HISTORIC AND DESIGN REVIEW COMPLIANCE AND TECHNICAL ADVISORY BOARD

HDRC CASE NO: 2024-024
COMMON NAME: including 104 Heiman
ADDRESS: 102 HEIMAN
LEGAL DESCRIPTION: NCB 679 BLK 1 LOT N IRR 65 FT OF 9
ZONING: D, HS, H
CITY COUNCIL DIST.: 2
DISTRICT: St Paul Square Historic District
LANDMARK: Individual Landmark
APPLICANT: Michael Abner/Smart Concepts Construction, LLC
OWNER: J E Aranda/EXECUTIVE REAL ESTATE GROUP LLC
TYPE OF WORK: Window infill, window replacement
APPLICATION RECEIVED: January 05, 2024
60-DAY REVIEW: March 6, 2024
CASE MANAGER: Jessica Anderson

The applicant requests a Certificate of Appropriateness for approval to replace existing metal casement and sash windows with fixed four-, six-, eight-, and 12-lite metal windows or four-over-four metal windows.

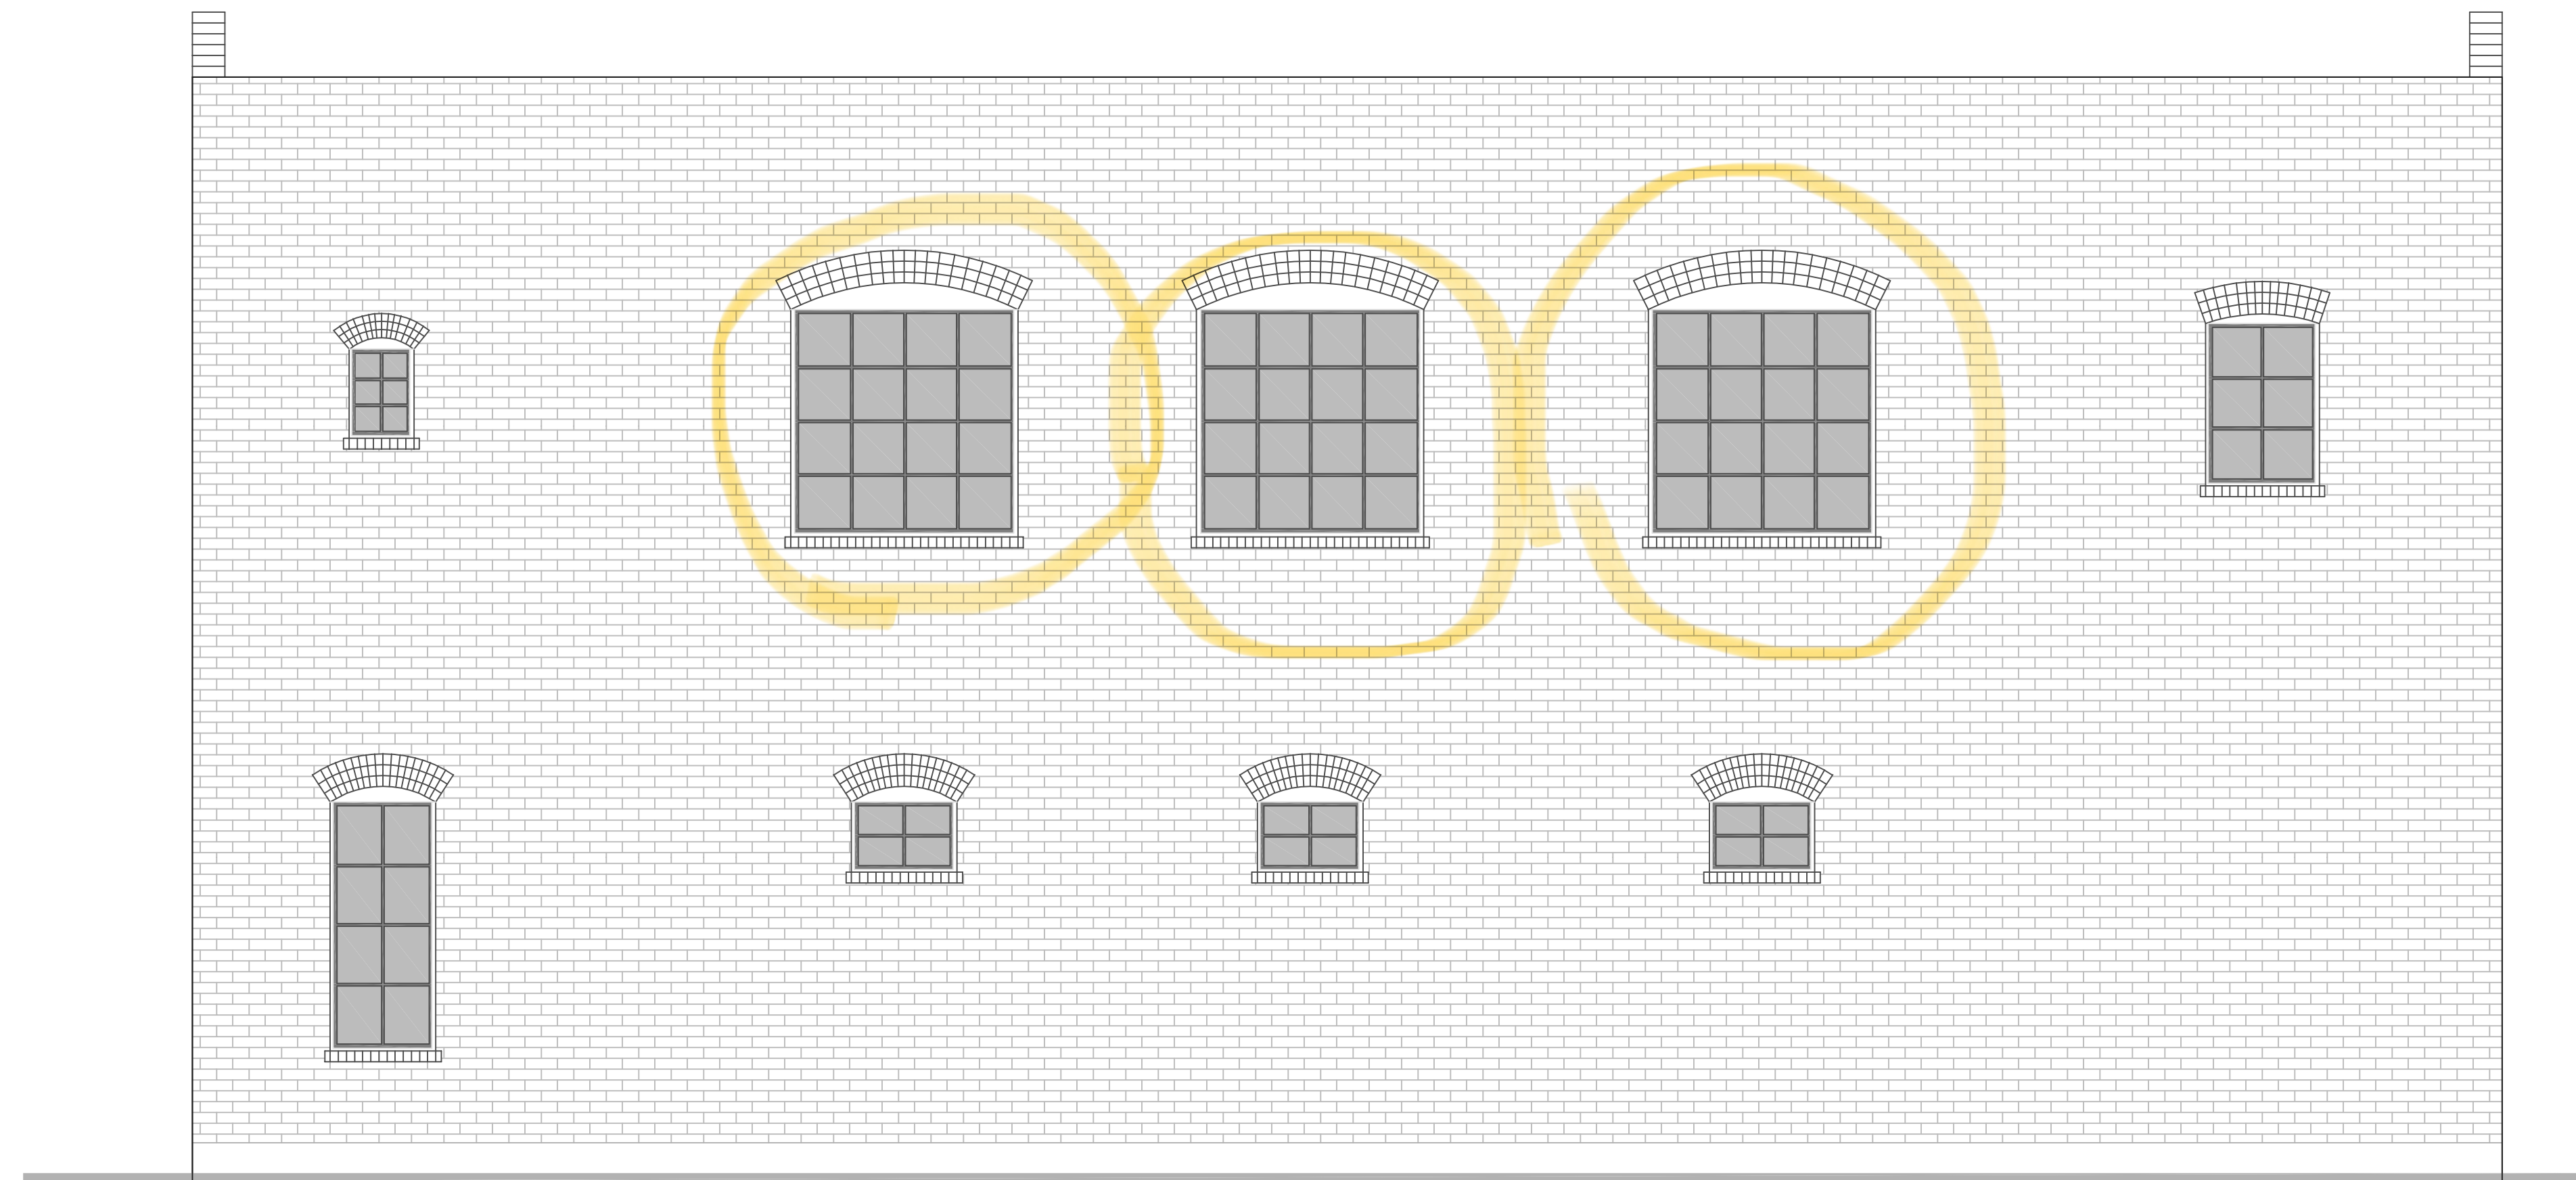
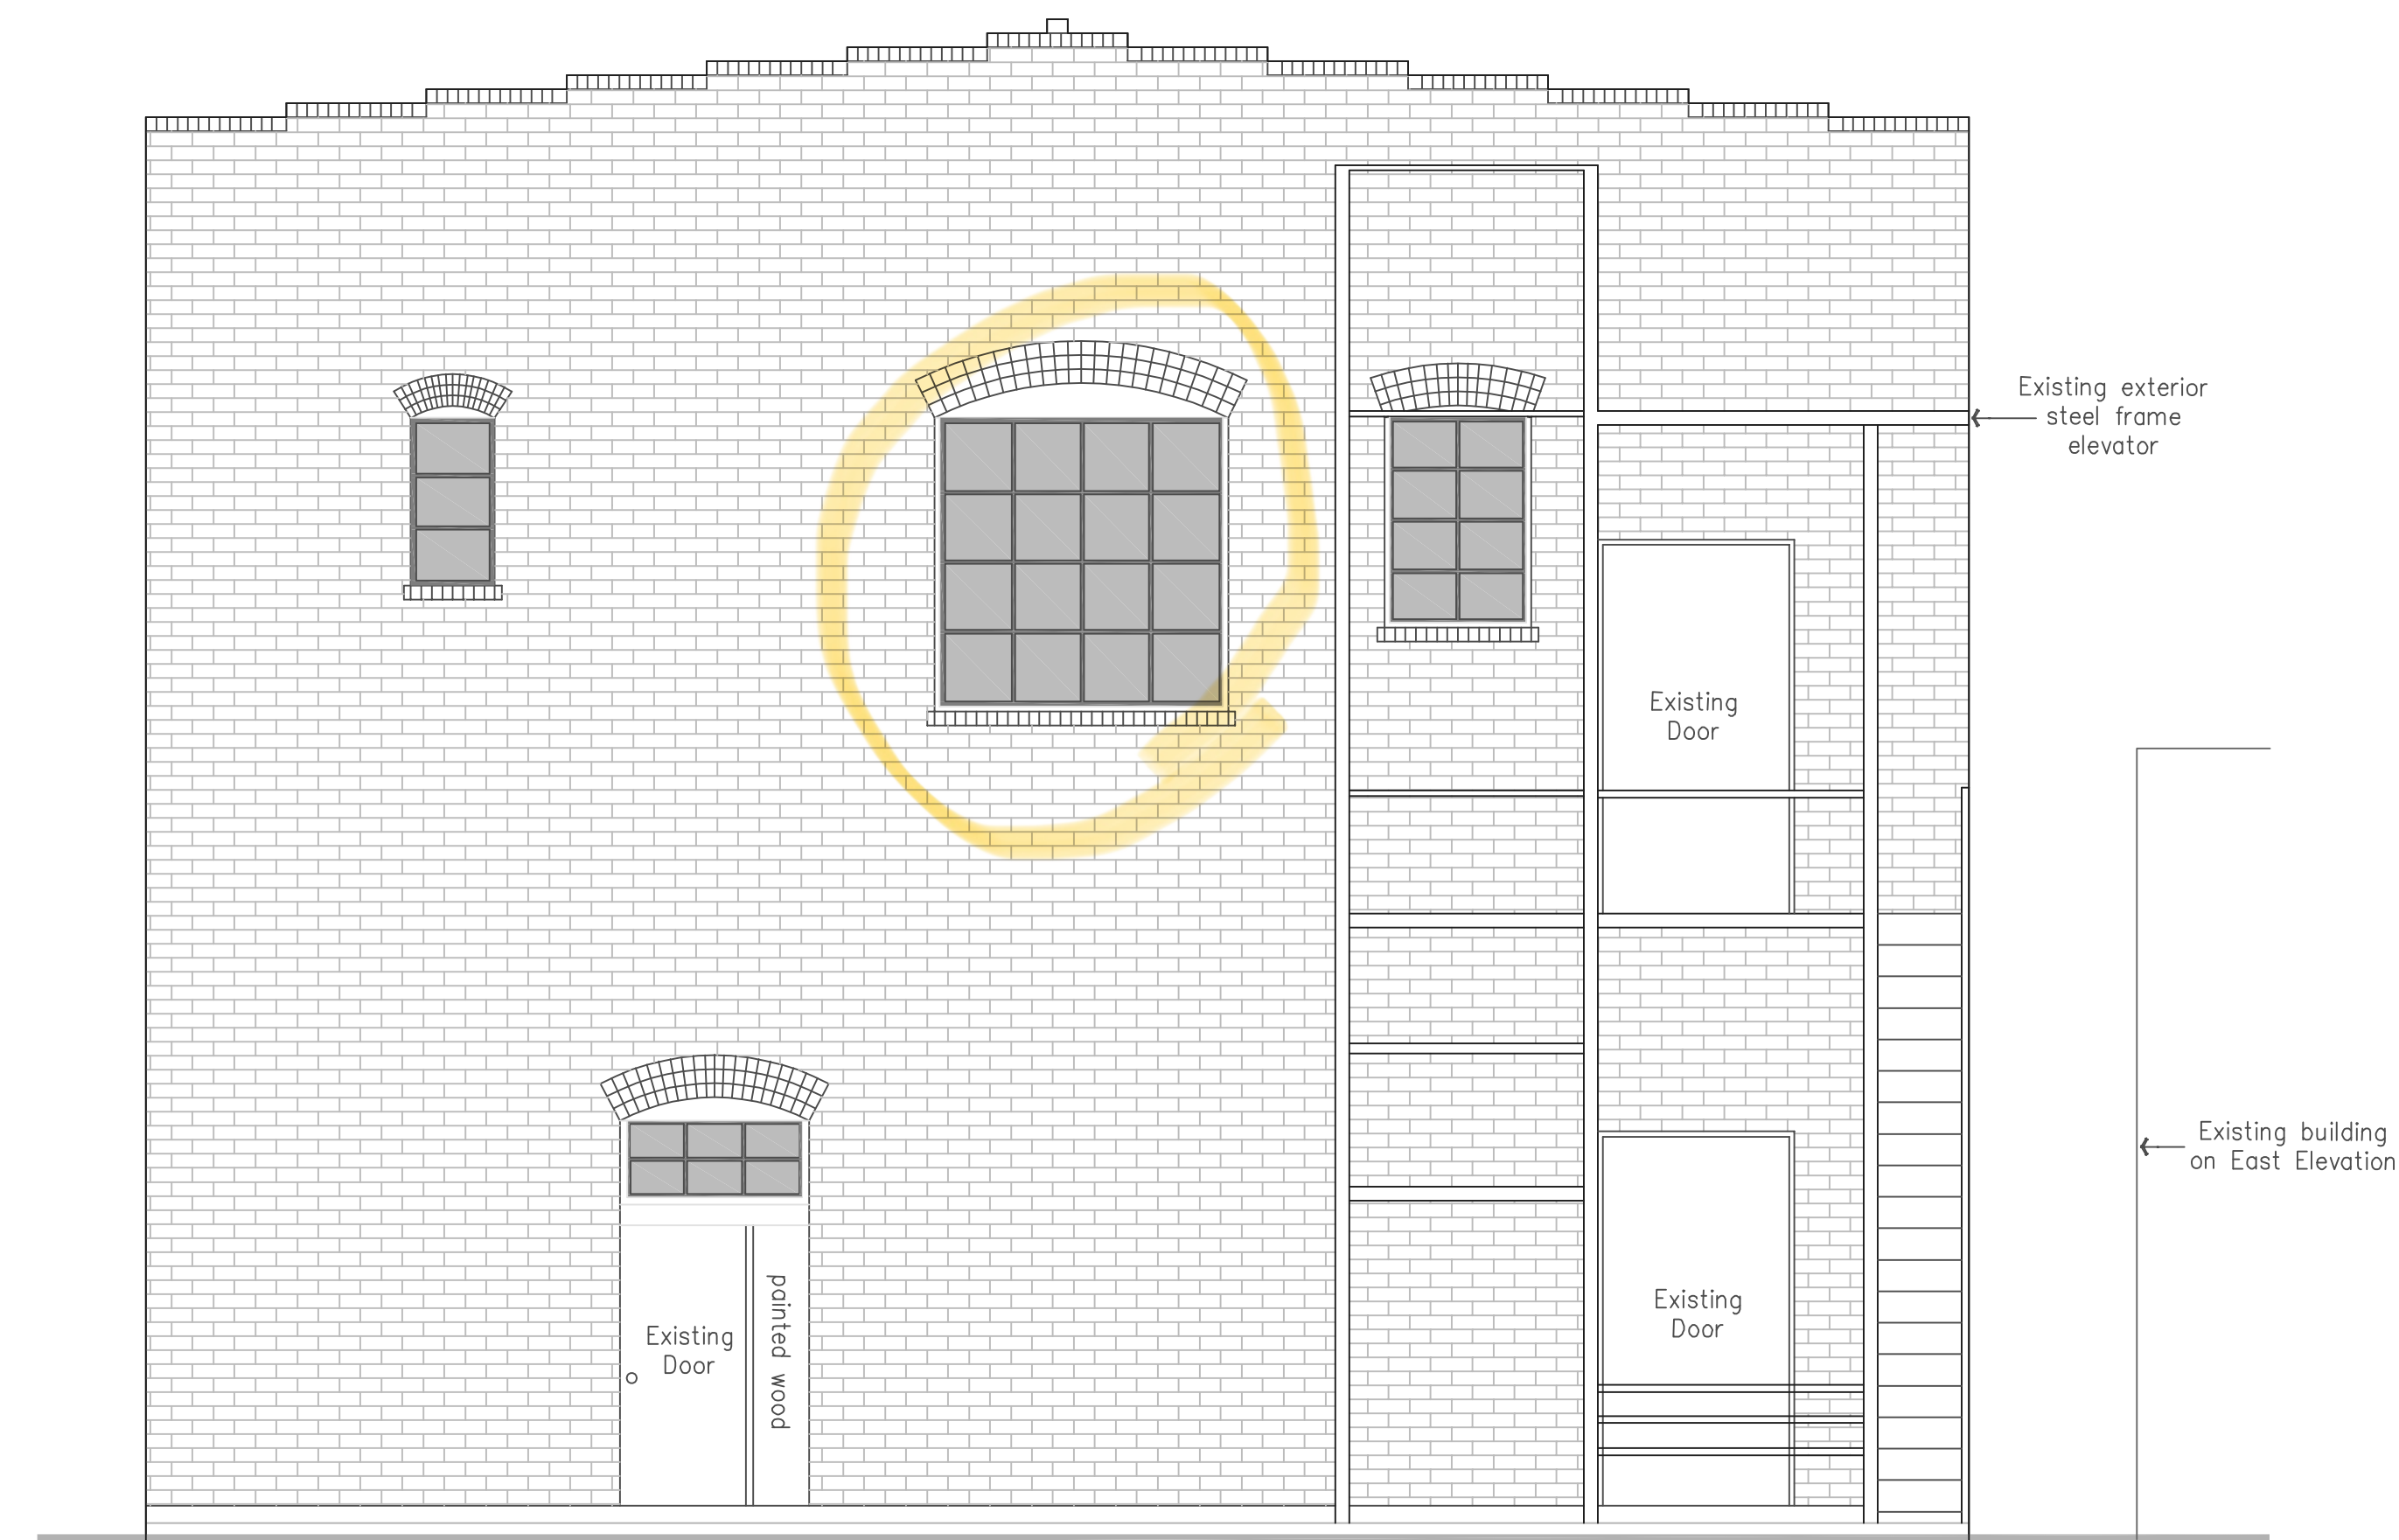
- c. **WINDOW REPLACEMENT:** The applicant requests approval to replace existing metal casement and sash windows with fixed four-, six-, eight-, and 12-lite metal windows or four-over-four metal windows. This

request includes installing metal windows in front of brick or stucco where windows were infilled without review and approval. Historic Design Guidelines for Exterior Maintenance and Alterations 6.A.i says preserve existing window and door openings. Avoid enlarging or diminishing to fit stock sizes or air conditioning units. Avoid filling in historic door or window openings. Guideline 6.B.iv says install new windows to match the historic or existing windows in terms of size, type, configuration, material, form, appearance, and detail when original windows are deteriorated beyond repair. Staff finds the request does not conform to guidelines. The applicant should propose to either return the windows to their previous conditions or, based on the age of the building, propose installation of a conforming wood or aluminum-clad wood sash window product across all elevations.

- d. **WINDOWS (MATERIAL):** The applicant has proposed a window product that includes nail fins and faux divided lites. The historic windows were set deep in the openings, which typically can not be accomplished using a product with a nail fin. Standard specifications for replacement windows say that glazing should not feature faux divided lights with an interior grille. If approved to match a historic window configuration, the window should feature real exterior muntins. Staff finds the proposed product does not conform to guidelines. Any window product proposed should be custom to fit existing masonry openings. Furring in of the openings to fit stock window sizes is not appropriate.

- i. That the applicant proposes to either return the windows to their previous conditions or, based on the age of the building, propose installation of wood or aluminum-clad wood sash windows across all elevations, as noted in finding c.

- ii. That if a wood or aluminum-clad wood window product is proposed, the product must meet staff's standard window stipulations, and the applicant must submit updated specifications to staff for review and approval. The windows should feature an inset of two (2) inches within facades and should feature profiles that are found historically within the immediate vicinity. Meeting rails must be no taller than 1.25" and stiles no wider than 2.25". White manufacturer's color is not allowed, and color selection must be presented to staff. There should be a minimum of two inches in depth between the front face of the window trim and the front face of the top window sash. This must be accomplished by recessing the window sufficiently within the opening or with the installation of additional window trim to add thickness. Window trim must feature traditional dimensions and architecturally appropriate sill detail. Window track components must be painted to match the window trim or concealed by a wood window screen set within the opening.

- iii. Windows should be custom to fit existing masonry openings, as noted in finding d. Furring in of the openings to fit stock sizes is not appropriate.
